WRG  
NEW MEXICO  
ENVIRONMENT DEPARTMENT ENTERED

July 28, 2010

**RE: DIRECTION FOR ADDITIONAL  
SOIL CONFIRMATION SAMPLE COLLECTION AND  
APPROVAL OF EXTENSION REQUEST  
RAILROAD RACK LAGOON OVERFLOW DITCH AND FAN-OUT AREA,  
SWMU No. 8 SUBSURFACE INVESTIGATION FINAL REPORT  
WESTERN REFINING COMPANY SOUTHWEST, INC., GALLUP REFINERY  
EPA ID # NMD000333211  
HWB-WRG-10-002**

**FIGURE 7**  
**RAILROAD RACK LAGOON OVERFLOW DITCH**  
**B-8 FINAL BASE AND SIDEWALL CONFIRMATION**  
**SAMPLE DRO RESULTS**  
**WESTERN REFINING**  
**GALLUP REFINERY**  
**GALLUP, NEW MEXICO**

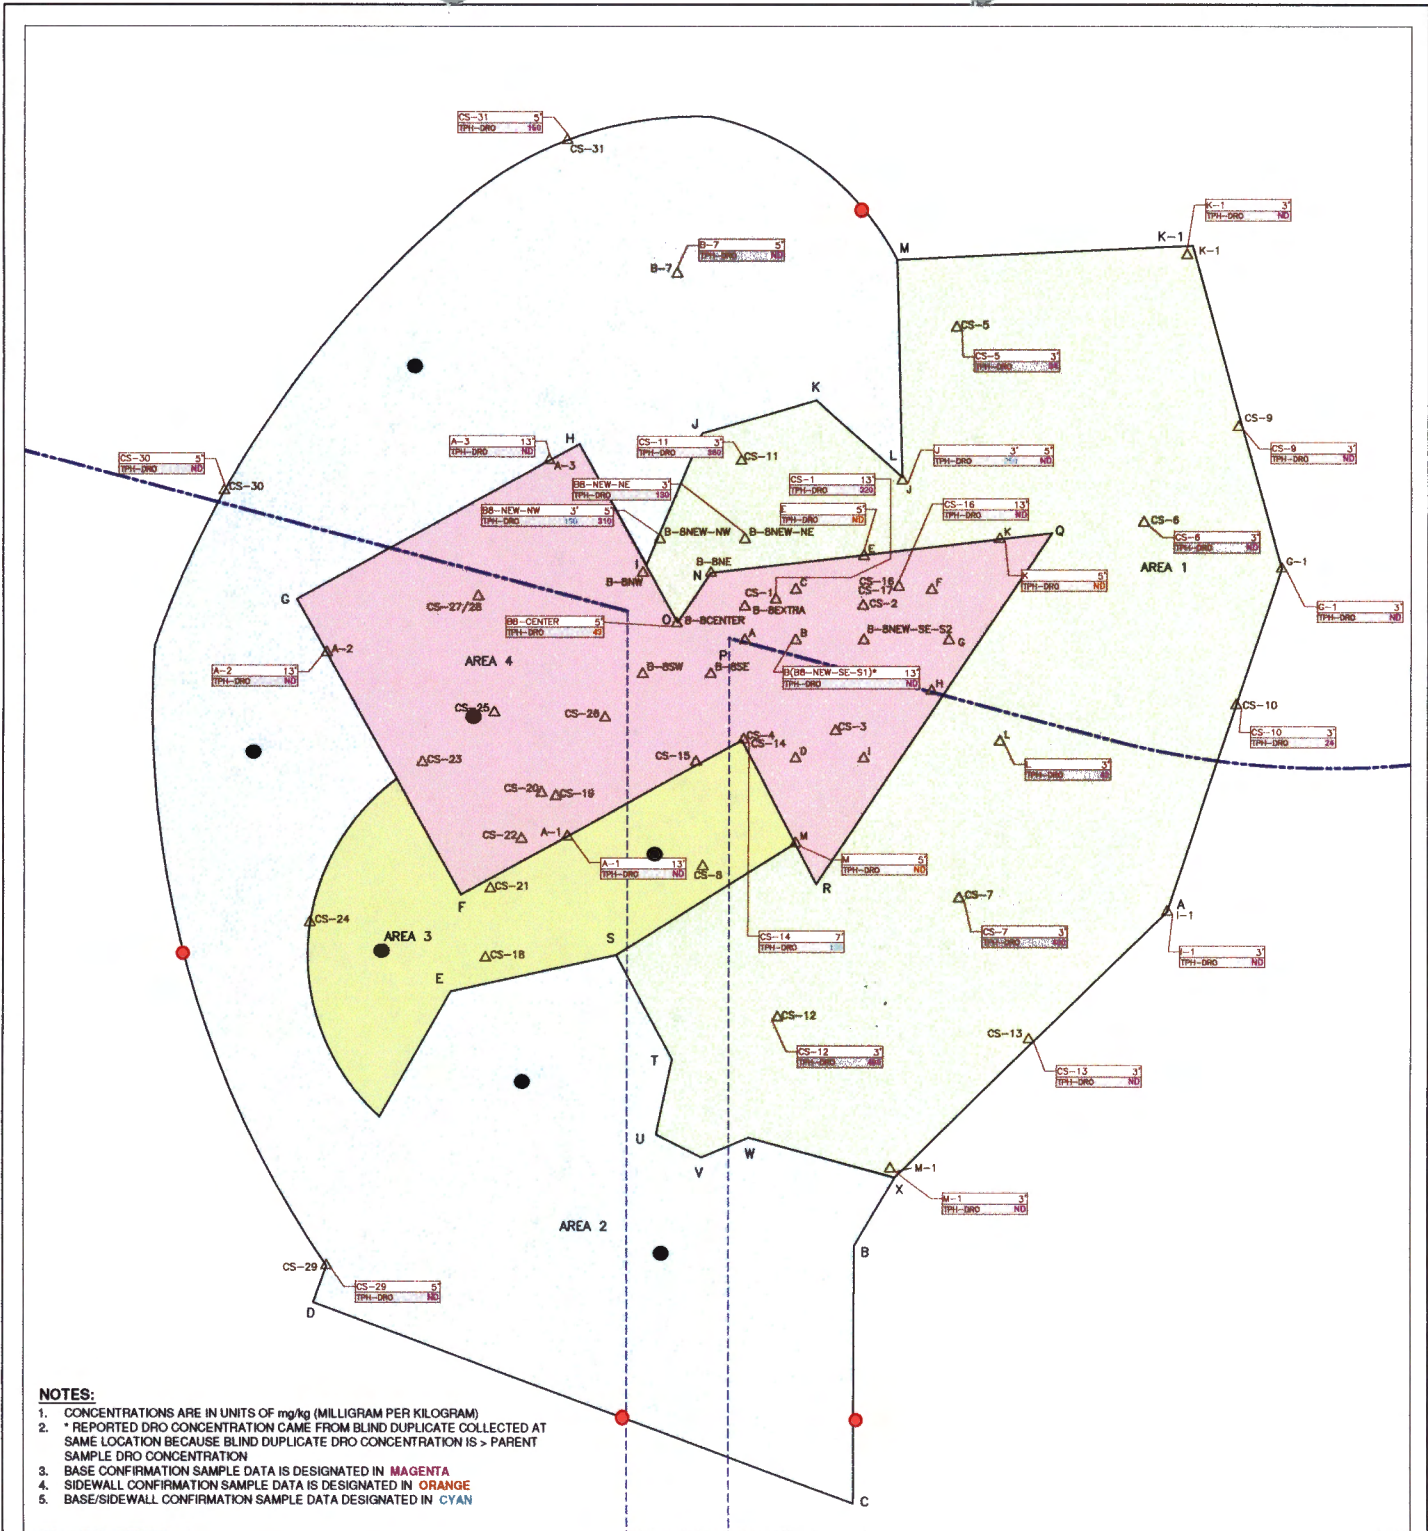
Report. However, the confirmation samples clearly do not cover the entire excavation. The Permittee's explanation regarding confirmation sample collection in the Response Letter does not address NMED's concerns regarding the spacing of confirmation samples. As a result there is insufficient information for NMED to determine that the site has been cleaned up to the 890 mg/kg diesel range organics (DRO) soil screening level listed in NMED's Total Petroleum Hydrocarbon (TPH) Screening Guidelines. In order to determine whether or not the removal of all soils containing concentrations of DRO above 890 mg/kg from the fan-out area was completed, the Permittee must collect samples from the base and sidewalls of the entire excavation. The Permittee must conduct additional confirmation sampling and, if necessary, conduct additional soil removal activities if the confirmation samples contain DRO concentrations greater than the acceptable cleanup level.

NMED has amended Figure 7 to illustrate confirmation sample locations where the Permittee must collect confirmation samples. The Permittee must collect soil samples at the locations shown on Figure 7 as well as at any locations where field screening (visual, olfactory) indicates evidence of contamination. The additional confirmation sampling is limited in scope and only covers areas where confirmation samples have not been collected. The samples must be submitted to a laboratory for DRO analysis by EPA method 8015.
